Access Compliance Report

Public Rights-of-Way

Intersection ID: 24993	Main Street: TRESANTON_DR	Cross Street: TYNE_CT	Location: SW
ADA ID: DA63F8BB473E	Ramp Type: PerpDiag	Initial Pass/Fail: Fail	Overall Compliance: No
			Severity Score: 25

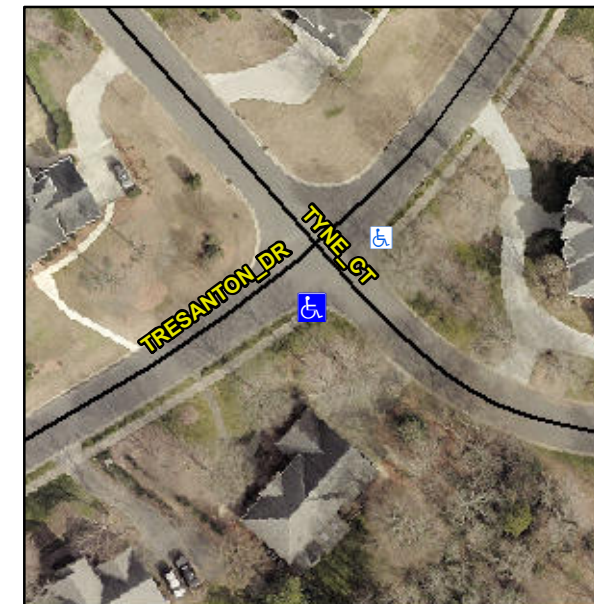
Not Found, R304.2.2, R304.5.3

Compliance	Description	Data	Compliance	Description	Data
N/A	Ramp Length (in)	32.0	No	Ramp Slope (%)	9.7
Yes	Ramp Width (in)	48.0	No	Ramp XSlope (%)	6.9
N/A	Flare Type LT	N/A	N/A	Flare Type RT	N/A
N/A	Flare Slope LT (%)	N/A	N/A	Flare Slope RT (%)	N/A
N/A	Flare Traversable LT?	N/A	N/A	Flare Traversable RT?	N/A
N/A	Landing Length (in)	N/A	N/A	DWS Provided?	N/A
N/A	Landing Width (in)	N/A	N/A	DWS Contrast?	N/A
N/A	Landing Slope (%)	N/A	N/A	DWS Length (in)	N/A
N/A	Landing X Slope (%)	N/A	N/A	DWS Full Width?	N/A
N/A	Landing Curb? (Y/N)	N/A	N/A	DWS Offset (in)	N/A
N/A	Shared Landing?	N/A			
N/A	Gutter Ponding?	N/A	N/A	Gutter Slope (%)	N/A
N/A	Gutter Lip Ht (in)	N/A	N/A	Gutter X Slope (%)	N/A
N/A	Painted X Walk1?	No	N/A	Painted X Walk2?	No
	X Walk 1 Direction	To NE		X Walk 2 Direction	To NW
N/A	X Walk 1 Width (in)	N/A	N/A	X Walk 2 Width (in)	N/A
	X Walk 1 Slope (%)	1.5		X Walk 2 Slope (%)	2.5
	X Walk 1 X Slope (%)	2.1		X Walk 2 X Slope (%)	1.1

Remove & Replace Curb Ramp With Two New Directional Ramps or Equivalent.
